Subject: AP1000 Responses to Requests for Additional Information (SRP3)

RAI-SRP3.7.1-SEB1-02 R2

AP1000 TECHNICAL REPORT REVIEW

RAI Response Number: RAI-SRP3.7.1-SEB1-02

Figure 1.0-1: Comparison of the HRHF horizontal input spectra to the CSDRS

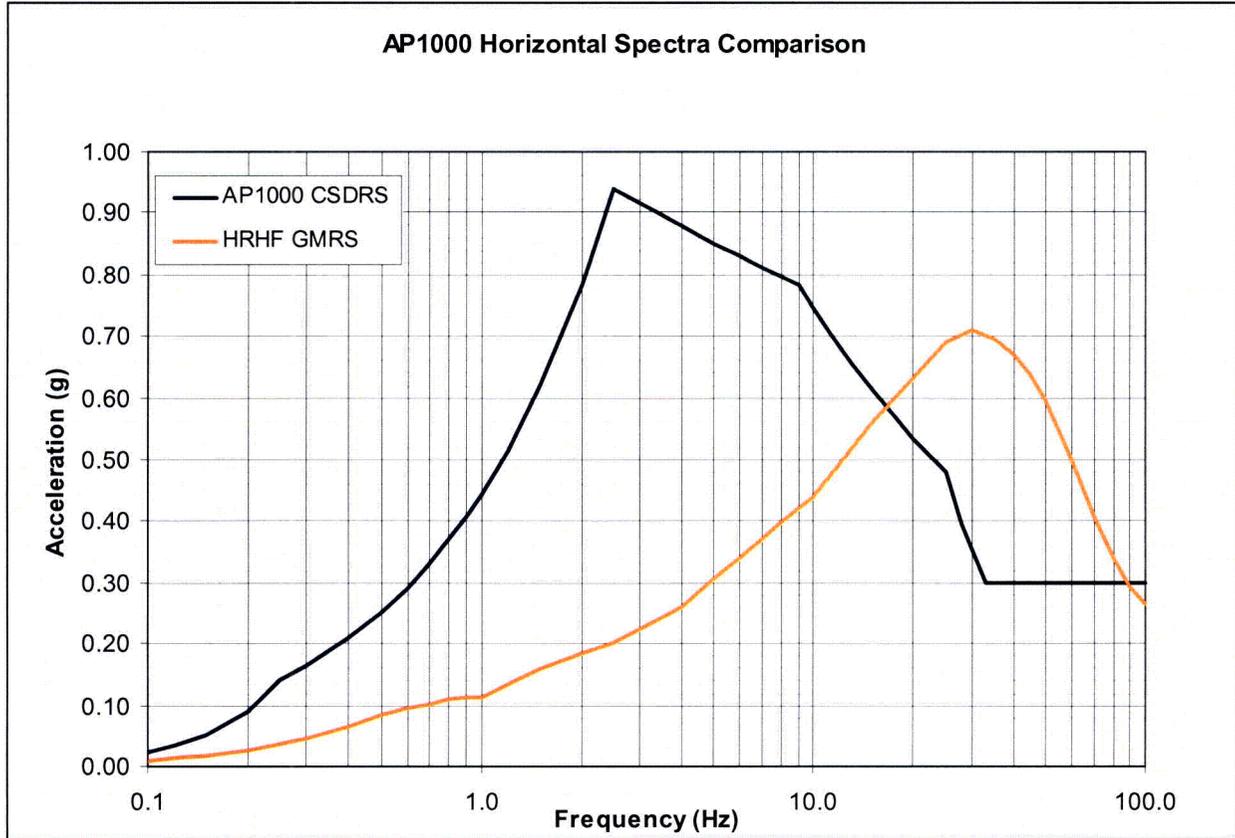
- b) HRHF shear wave velocity profile is shown in Table RAI-SRP3.7.1-SEB1-02-1.
- c) Two horizontal and one vertical synthesized time history was generated which enveloped the HRHF GMRS shown below in Figure 1.0-1 and Figure 1.0-2 under the section titled "Technical Report (TR) Revision." The HRHF GMRS time histories are applied at NI foundation level of 60.5 ft. HRHF GMRS and FIRS are identical for the HRHF sites.

A Hard Rock High Frequency (HRHF) spectrum has been developed that envelopes three hard rock sites for which Combined License applications using the AP1000 as the vendor design are being prepared. Figures 1.0-1 and 1.0-2 compare the HRHF at foundation level against the AP1000 CSDRS for both the horizontal and vertical directions for 5% damping. The HRHF exceeds the CSDRS for frequencies above about 15 Hz. Evaluations in this report ~~describe the seismic input at a hard rock site where the nuclear island is founded on hard rock~~ are for Ground Motion Response Spectra (GMRS) with high frequency input.

Modify Figures 1.0-1 and 1.0-2 to be consistent with Figures 5.0-3 and 5.0-4 given in TR-144.
